Attached please find my professional review and opinion letter for the project located at 60 Franklin Street in the Historic Dublin District.

HISTORICAL ANALYSIS AND DESIGN REVIEW:

Property Address: 60 Franklin Street
Dublin, Ohio 43016

Examples of Mid-century entrances and porches:

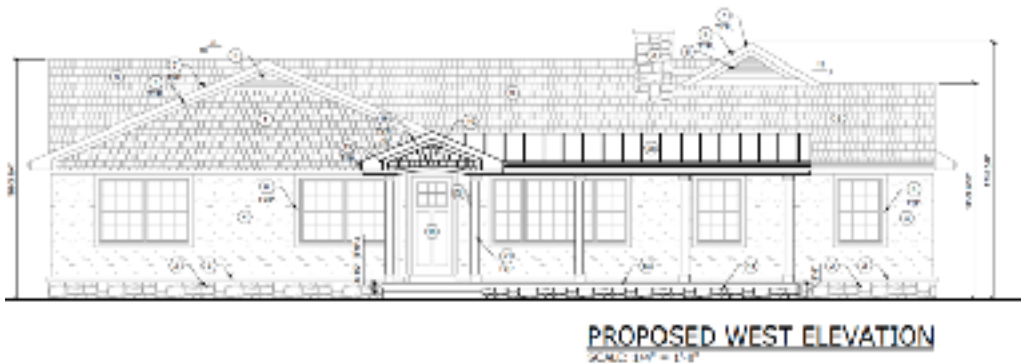
The typical homes on this block have either no porches or porches that are not additive and are carved into the house sharing the roof of the primary structure with a recessed entry. Although the front of this home has already been altered from its original form, there is an opportunity to create a front porch that is more in keeping with Mid-century modern massing and simplicity. Typical Mid-century modern homes do not have additive, or projecting entry ways but rather have carved out or subtractive entrances. Additionally, Mid-century modern porches are traditionally covered by extensions or protrusions of the primary roof with large overhangs.
